Service Letter No. 400

SUBJECT: Tail Brace Rods

MODELS AFFECTED: All PA-12, PA-14 and PA-20 Aircraft and  
PA-22 Tri-Pacer Aircraft Serial Nos. 22-1 to 22-7999 incl.

### STABILIZED TIE ROD ATTACHMENT

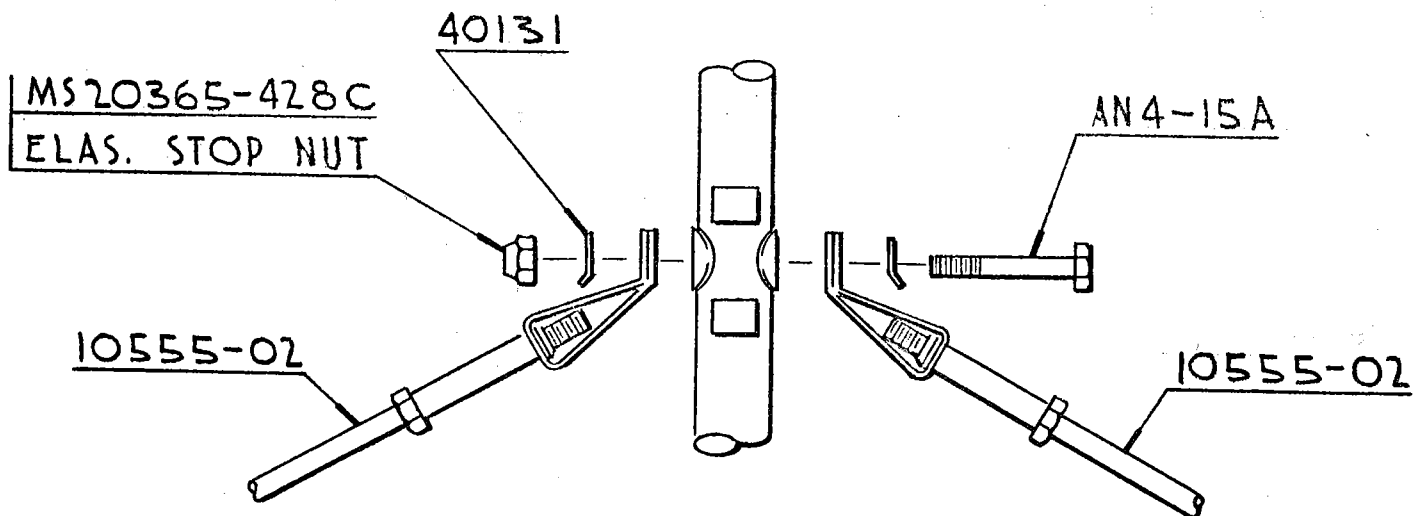
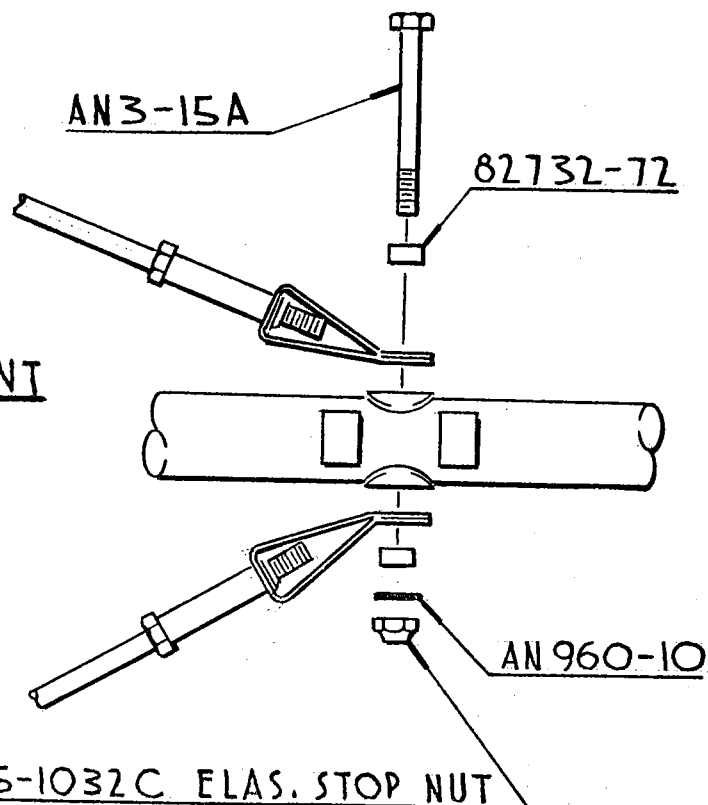
We wish to announce that the round upper and lower tail brace tie rod assemblies, part numbers 10555-02 and 10556-02, respectively, have been approved to replace the upper and lower streamline tail brace tie rod assemblies, part numbers 10074-02 and 10074-03, on PA-12, PA-14, PA-20 and PA-22 aircraft, serial numbers listed above.

The installation of the round tail brace tie rods will eliminate compliance with Piper Service Bulletin No. 183 and F.A.A. AD-60-1-7. Therefore, it is recommended that as the streamline tie rods are retired from service, the round tie rods be installed as a replacement. See Sketch on reverse side for complete details.

NOTE- SECURE ATTACHMENT PARTS AS SHOWN TO COMPLY WITH THIS SERVICE LETTER.
